# 6 MG CELESTIAL ROAD GROUND STORAGE TANK

TOWN OF ADDISON  
 DALLAS COUNTY, TEXAS  
**6 MG CELESTIAL ROAD STORAGE TANK**

# ONE 6.0 MILLION GALLON WATER STORAGE TANK CONTRACT NO. 86 PE 004 WITH TOWN OF ADDISON, COUNTY OF DALLAS, TEXAS CONSULTING ENGINEERS: GINN INC.

**PLAN SONIC LEVEL TRANSMITTER**

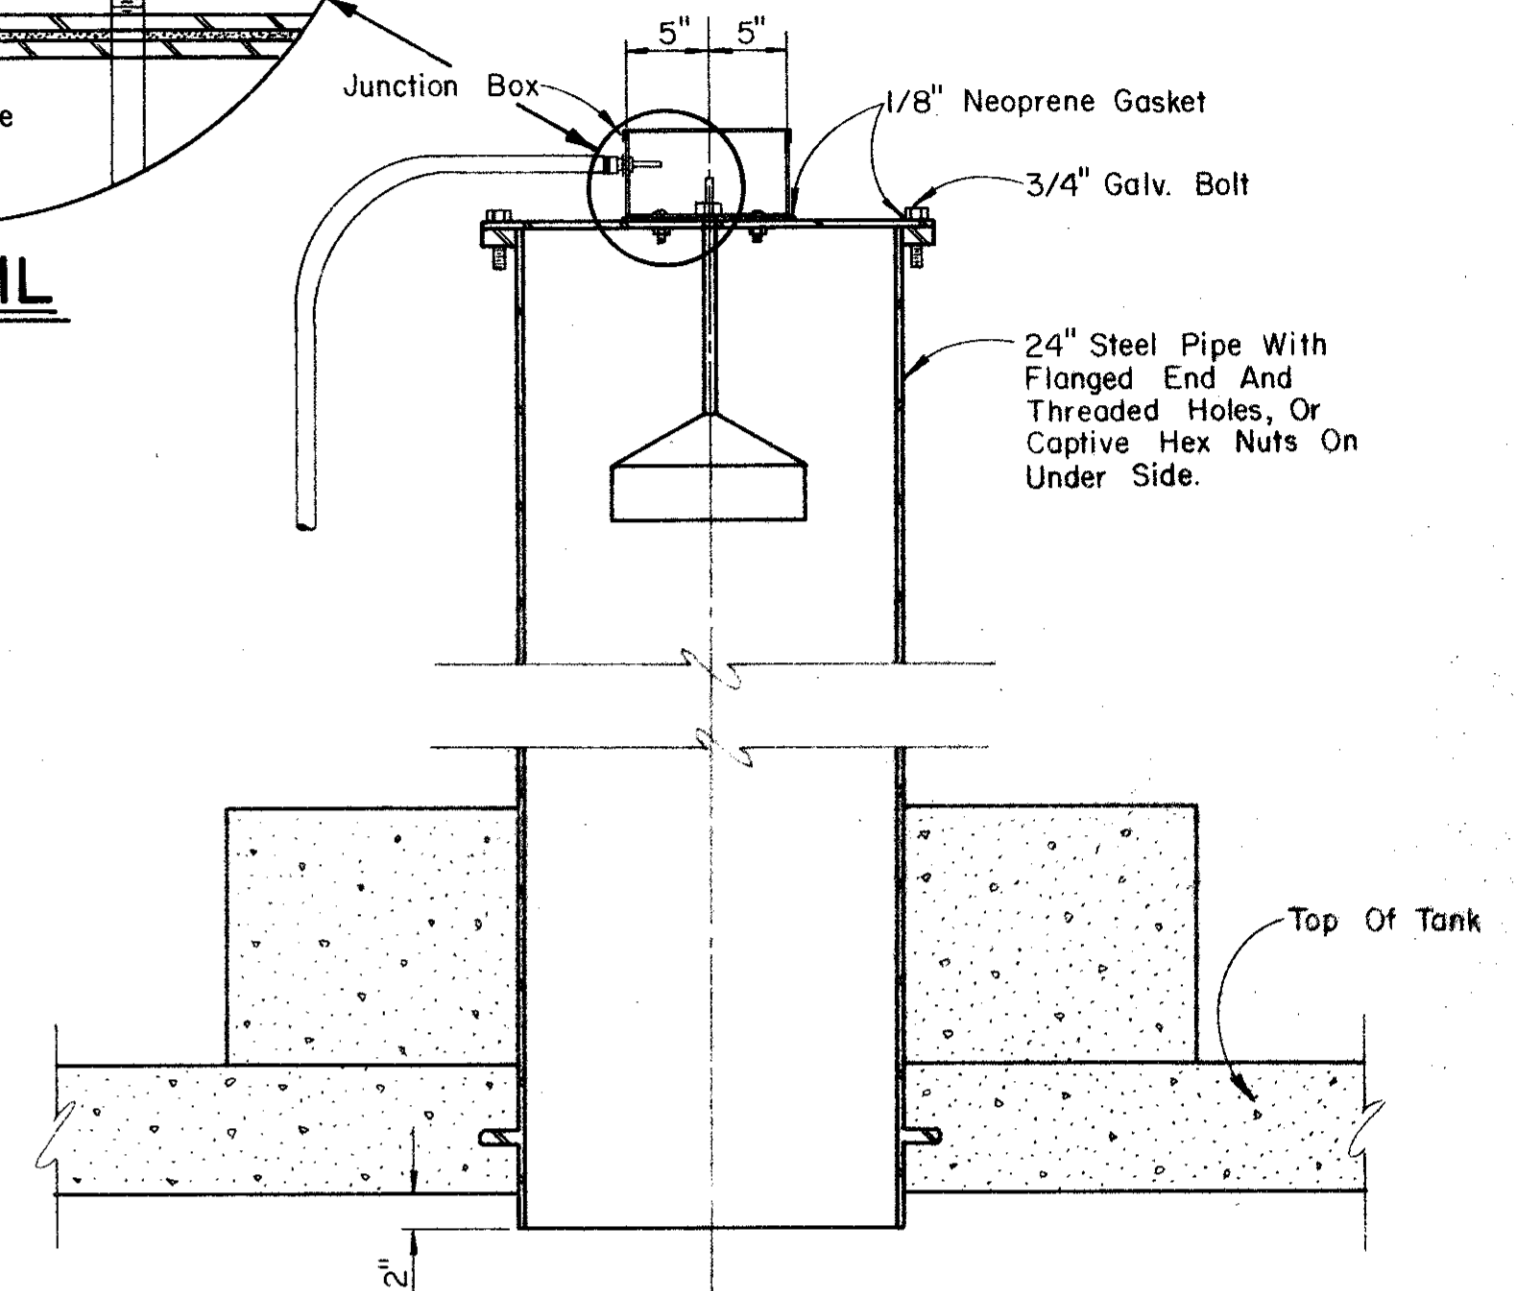
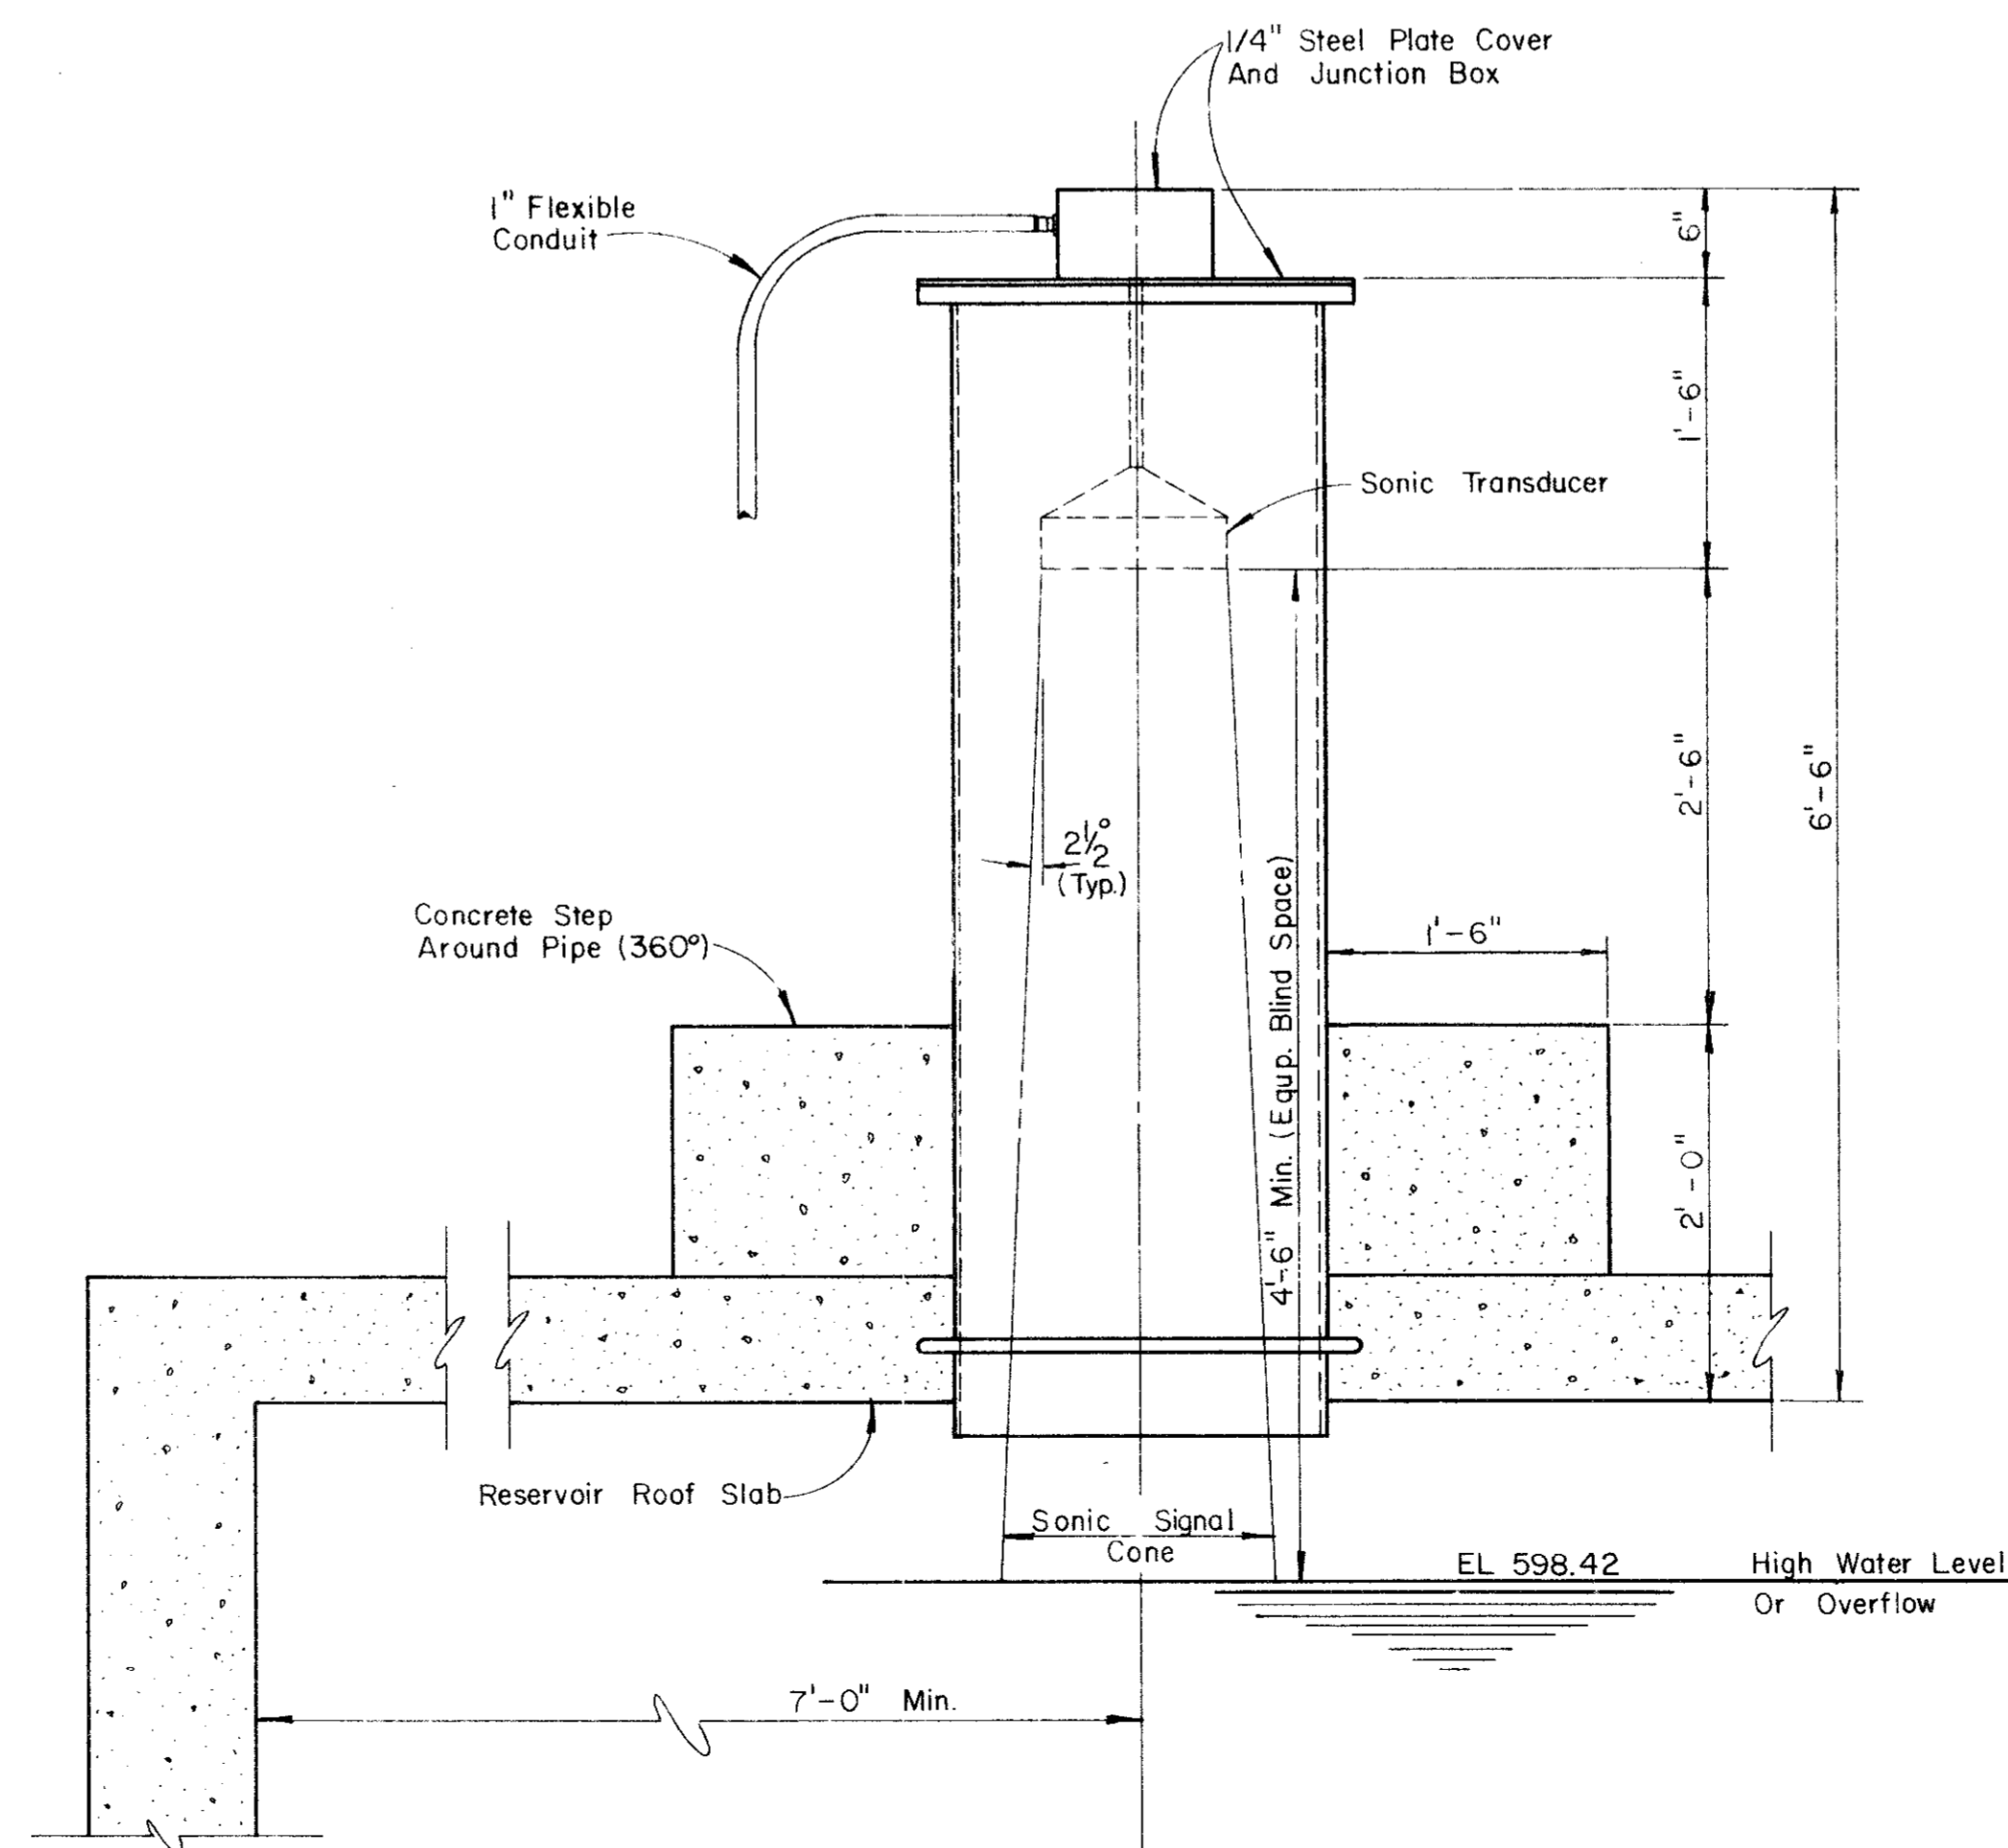
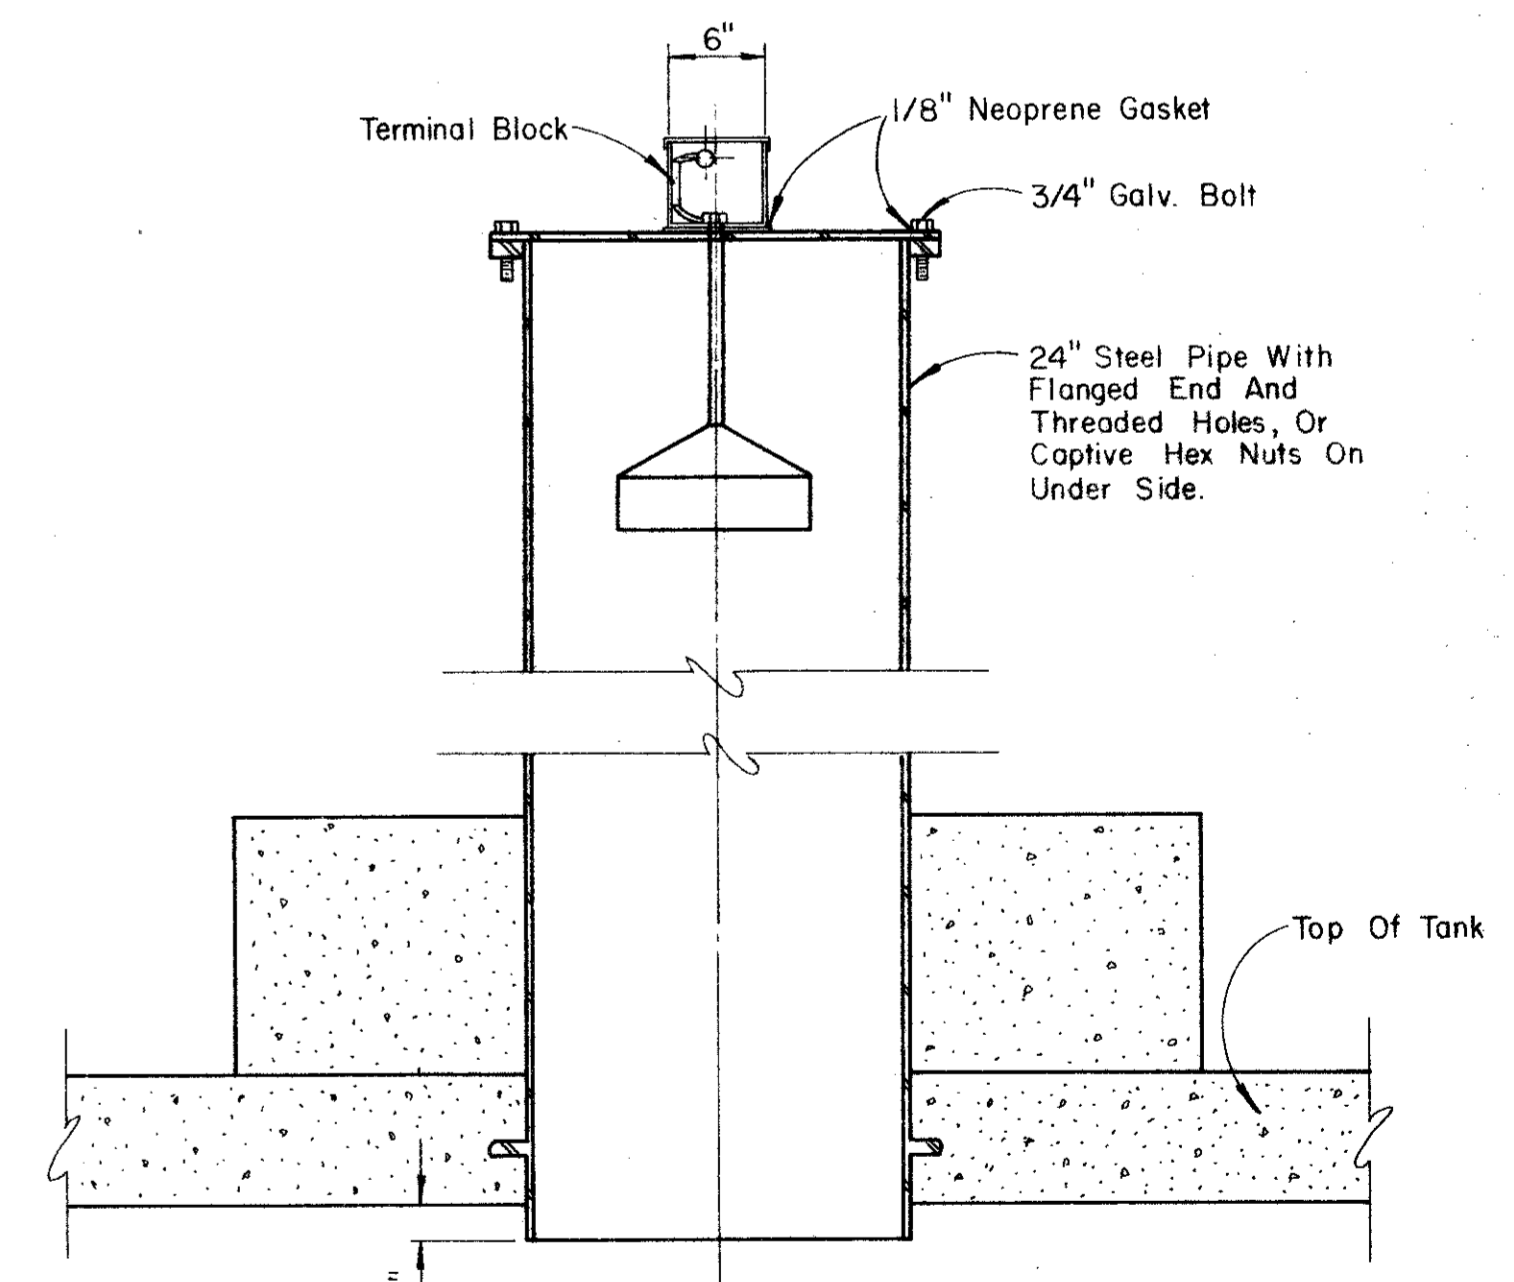
1 SONIC LEVEL TRANSMITTER ADDENDUM #1		RCH	5-7-86
No.	Revision	By	Date
TOWN OF ADDISON DALLAS COUNTY, TEXAS			
<b>6 MG CELESTIAL ROAD STORAGE TANK</b>			
<b>MISCELLANEOUS TANK DETAILS</b>			
GINN, INC. Consulting Engineers Dallas, Texas			
Designed - RCH	Drawn - ALA	Date - FEB. 1986	Job No. - 215
Approved - HWG	Checked - GF	Scale - AS SHOWN	Sheet 4 of 8

**6' x 4' CAST-IN-PLACE CULVERT**

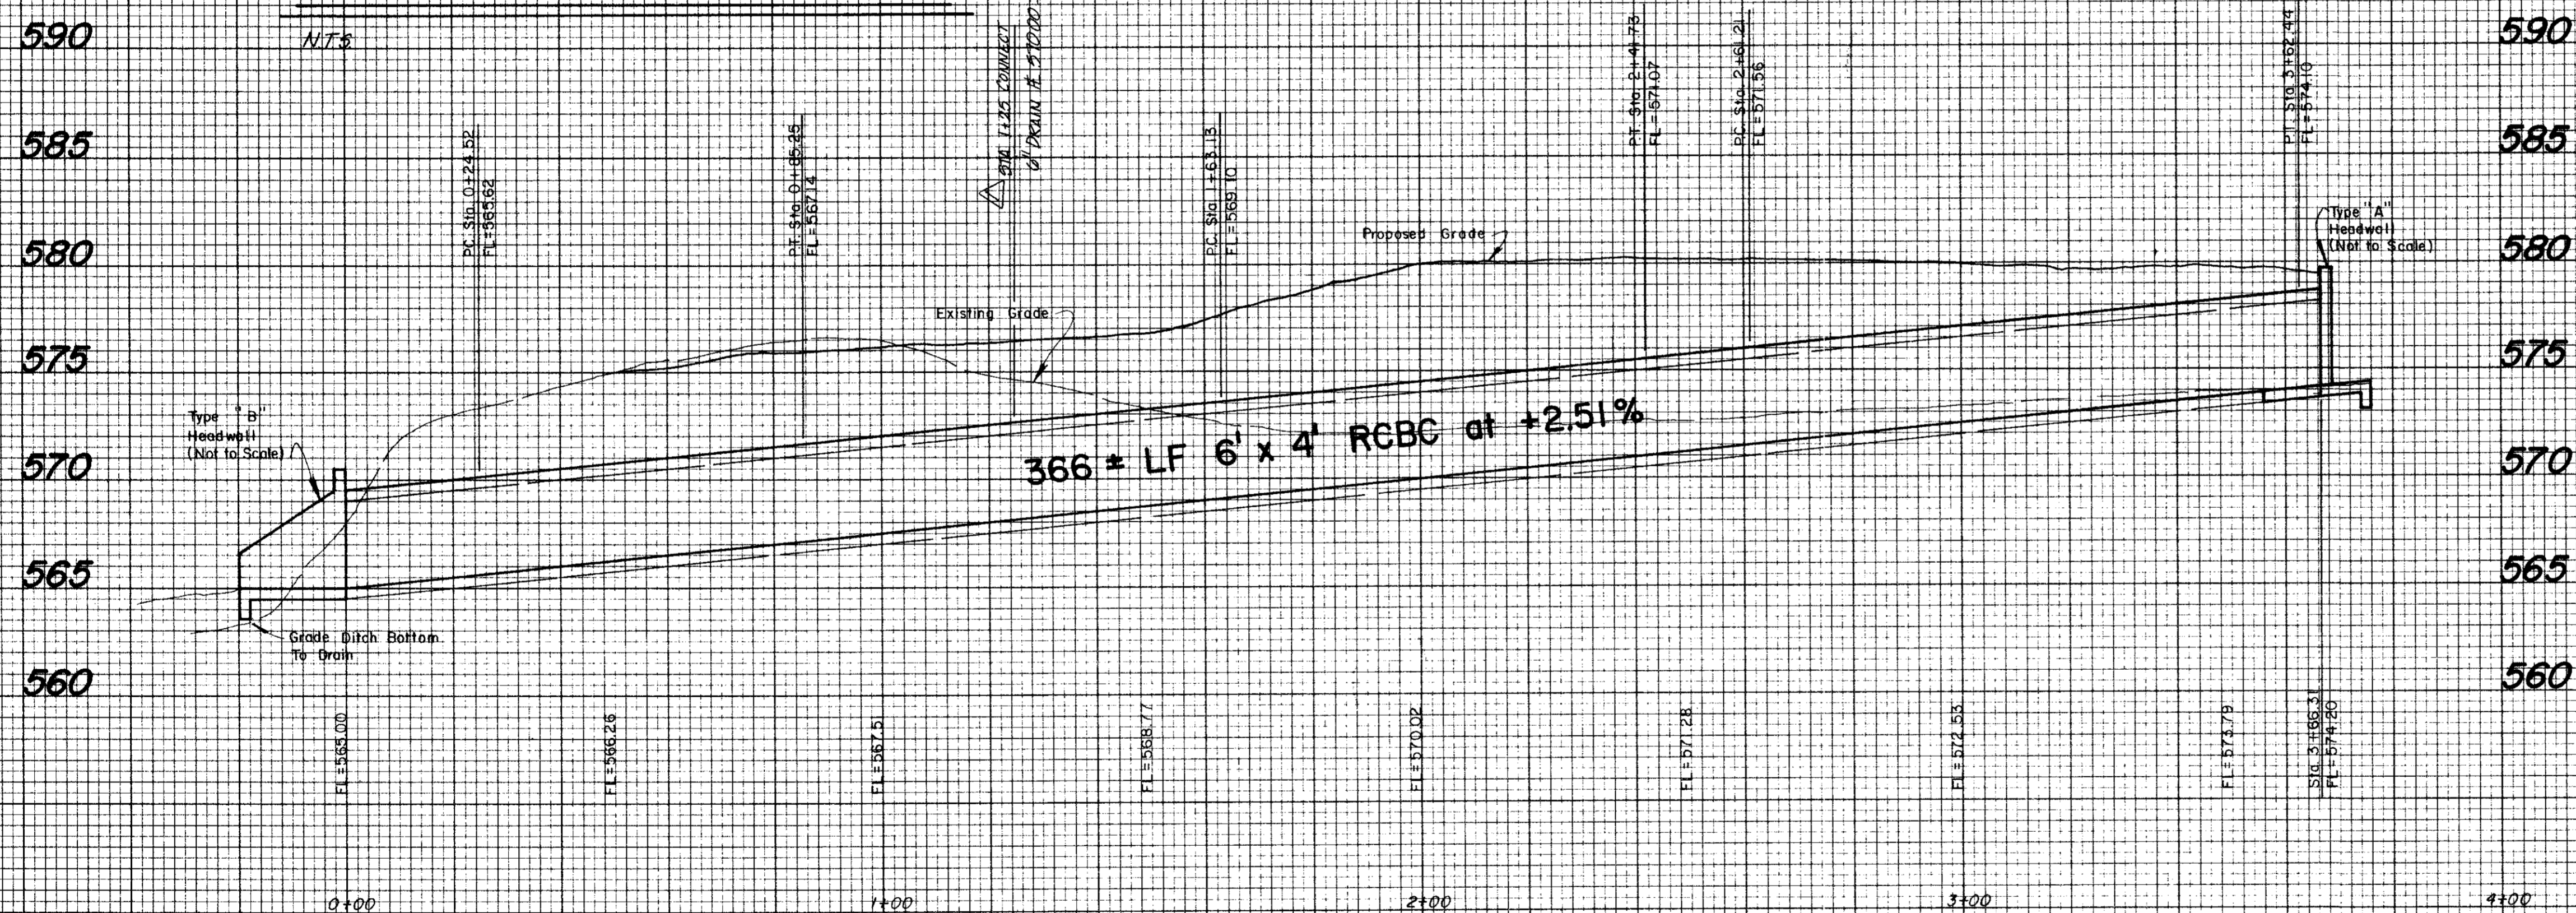
ADD 6" PVC CONNECTION		REVISION		DATE	
TOWN OF ADDISON DALLAS COUNTY, TEXAS					
<b>6 MG CELESTIAL ROAD STORAGE TANK</b>					
<b>BOX CULVERT PROFILE</b>					
<b>GINN, INC</b>					
Consulting Engineers		Dallas, Texas			
Designed: RCH	Drawn: ALA	Date:	Job No.:	DIB	
Approved: HWG	Checked: RCH	Scale: 1/4" = 1'-0"	Sheet: 6	of 8
